FED. ROAD DIST. NO.	STATE	PROJ. NO.	FISCAL YEAR	SHEET NO.	TOTAL SHEETS
HAWAII	HAW.	30A-01-10M	2011	ADD. 2	40

4/21/11	Placed dot on No. D-03, per Addendum No. 1
DATE	REVISION
STATE OF HAWAII DEPARTMENT OF TRANSPORTATION HIGHWAYS DIVISION STANDARD PLANS SUMMARY HONOAPIILANI HIGHWAY RESURFACING Vicinity of Hoohui Road to Plantation Estates Golf Course Project No. 30A-01-10M Date: April, 2009

ADD. 2

STATE OF HAWAII
 DEPARTMENT OF TRANSPORTATION
 HIGHWAYS DIVISION
ROADWAY PLAN
HONOAPIILANI HIGHWAY RESURFACING
 Vicinity of Hooihui Road to Plantation Estates Golf Course
 Project No. 30A-01-10M
 Scale: 1" = 40' Date: May, 2009
 SHEET No. 9 OF 9 SHEETS

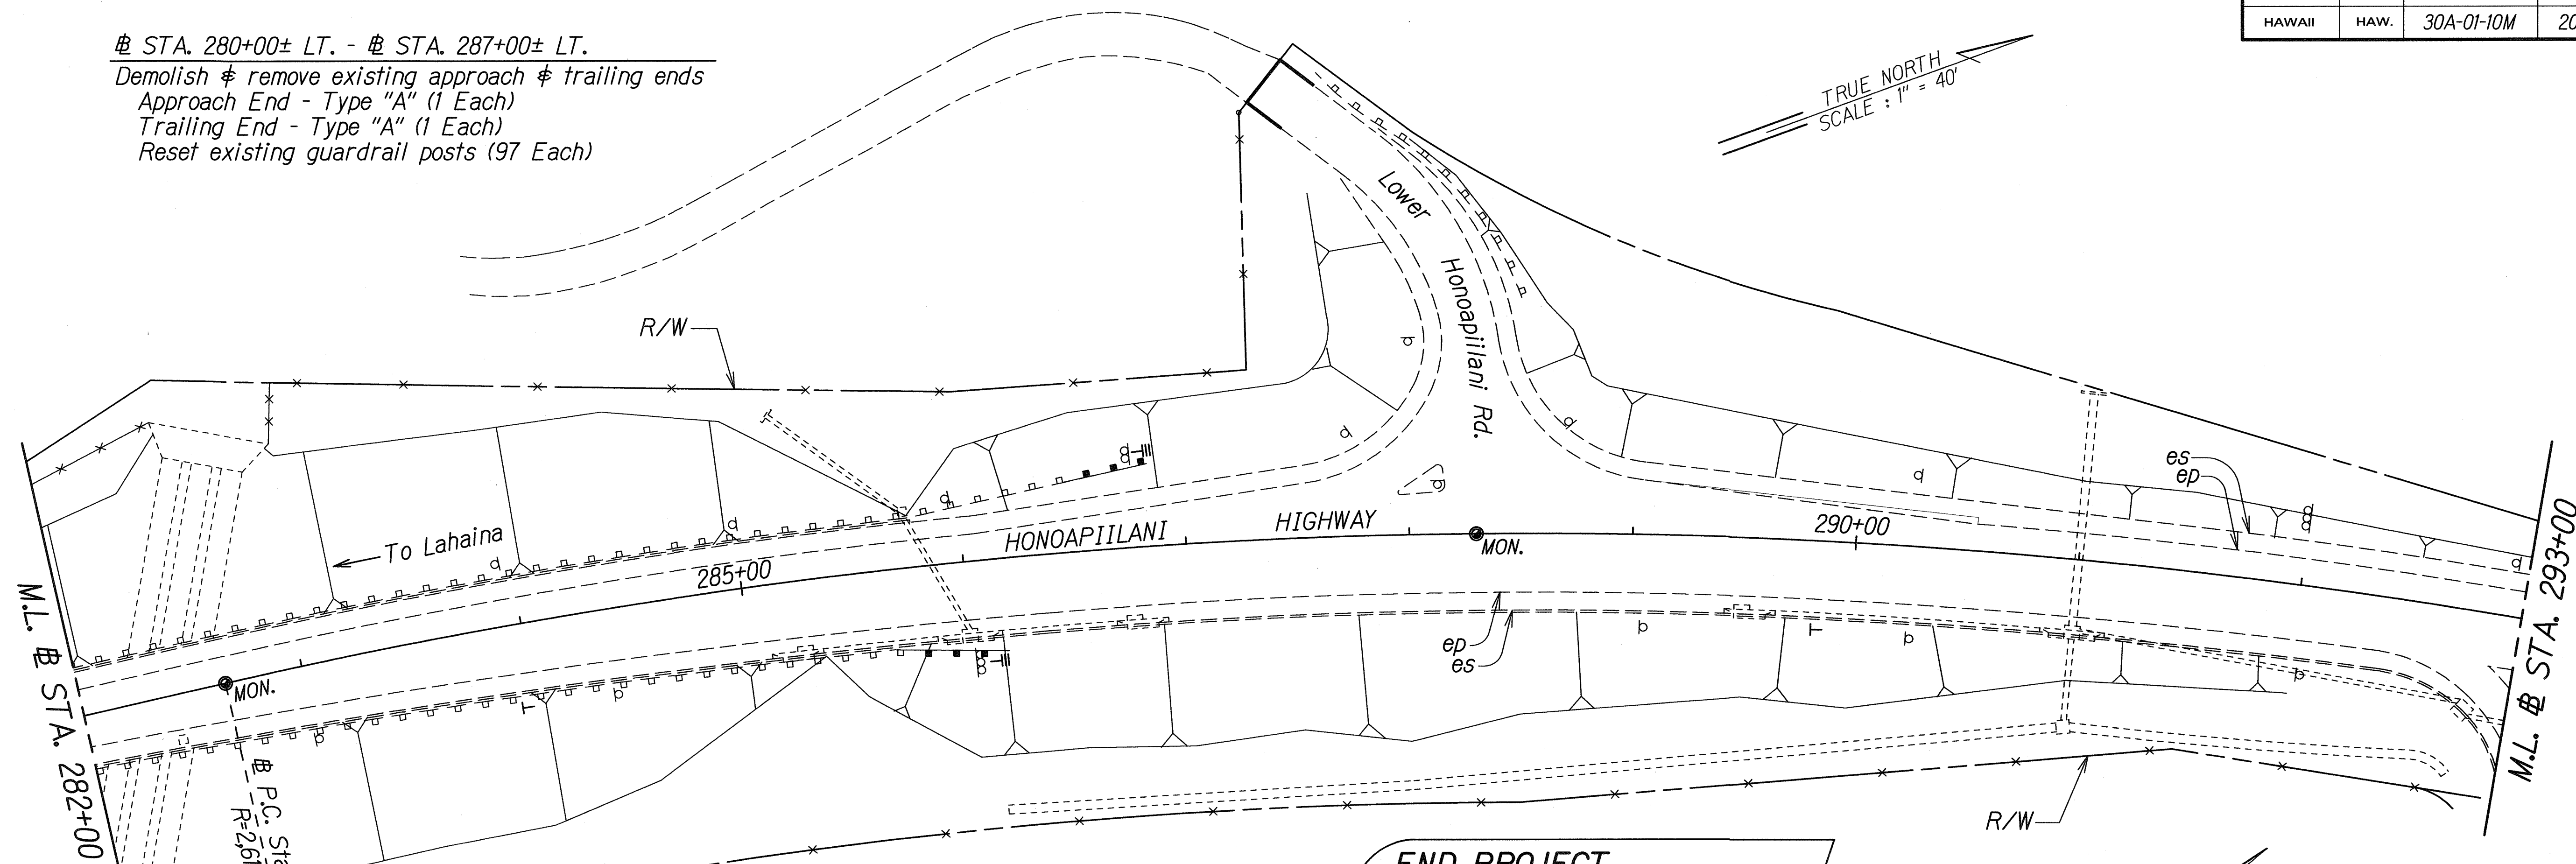
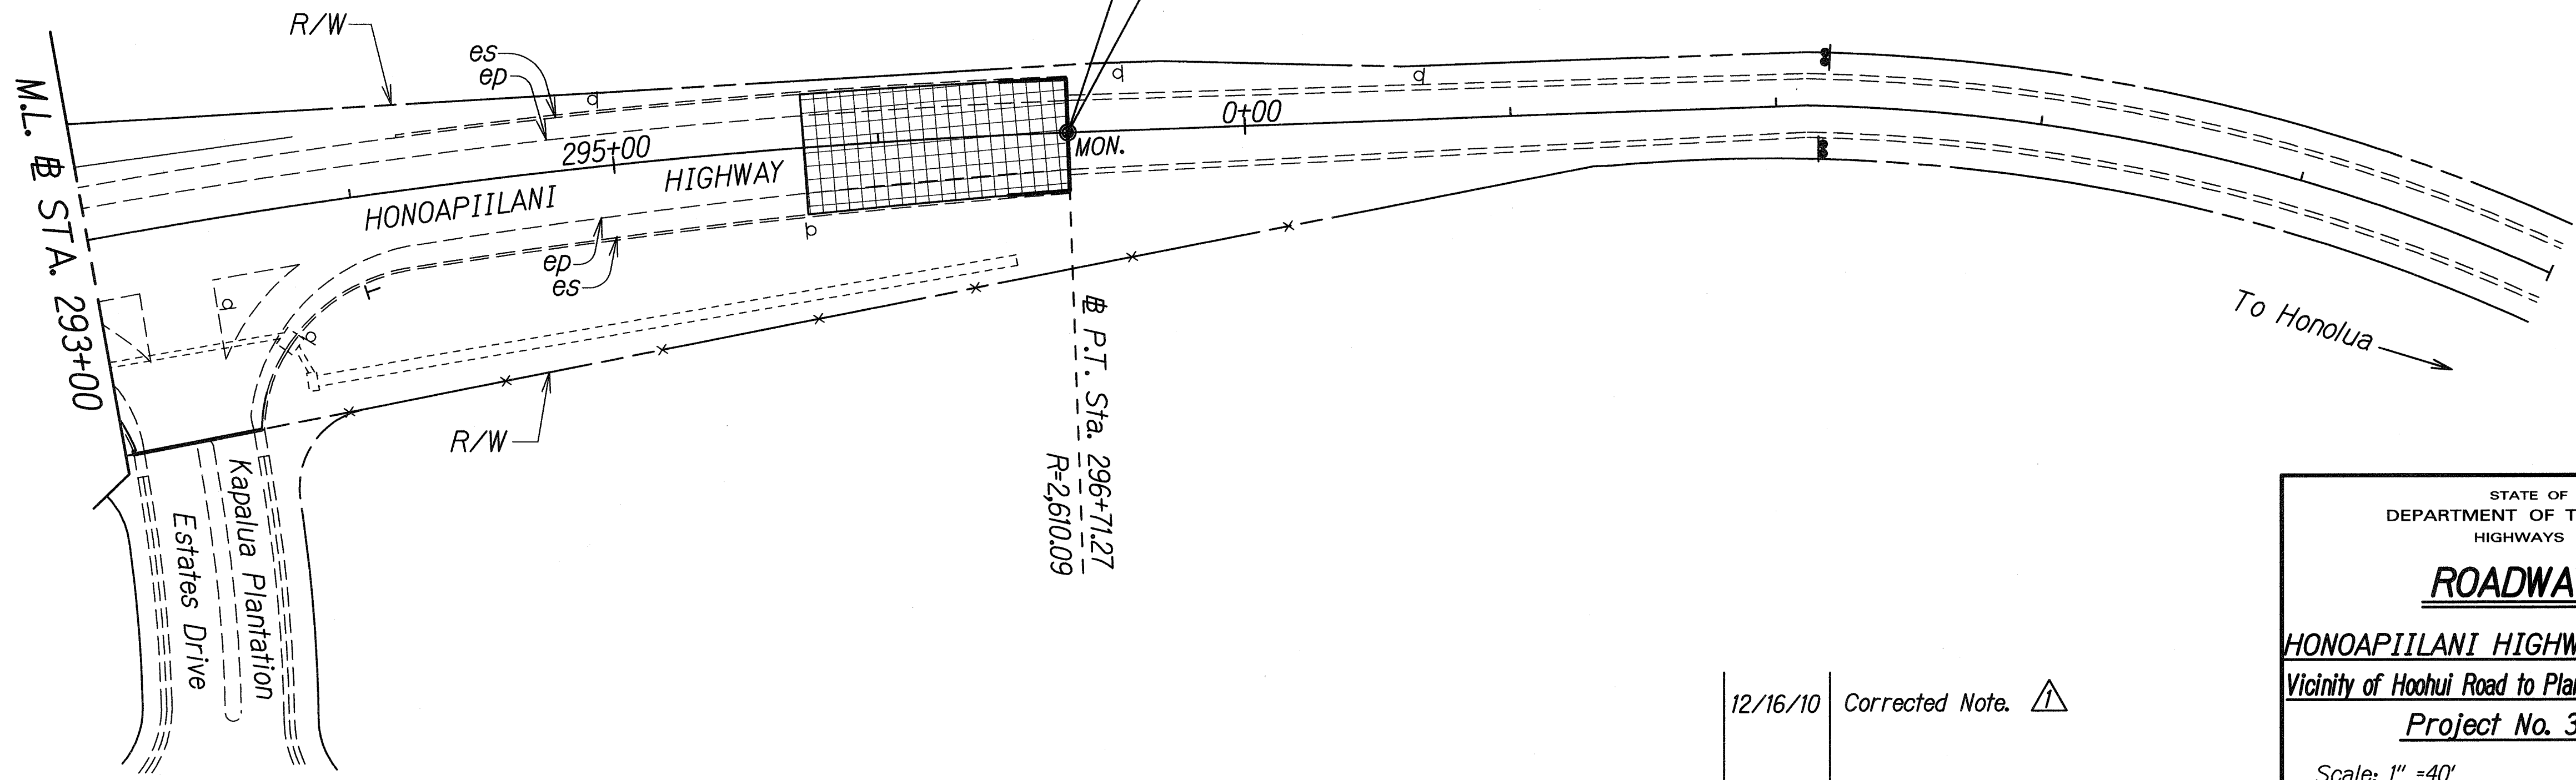
12/16/10	Corrected Note.
DATE	REVISION

± STA. 280+00± LT. - ± STA. 287+00± LT.
 Demolish & remove existing approach & trailing ends
 Approach End - Type "A" (1 Each)
 Trailing End - Type "A" (1 Each)
 Reset existing guardrail posts (97 Each)

± STA. 279+50± RT. - ± STA. 286+00± RT.
 Demolish & remove existing approach & trailing ends
 Approach End - Type "A" (1 Each)
 Trailing End - Type "A" (1 Each)
 Reset existing guardrail posts (89 Each) & Replace
 Posts on Top of 2 Catch Basins (± Sta. 281+00± & ± Sta. 282+50±).
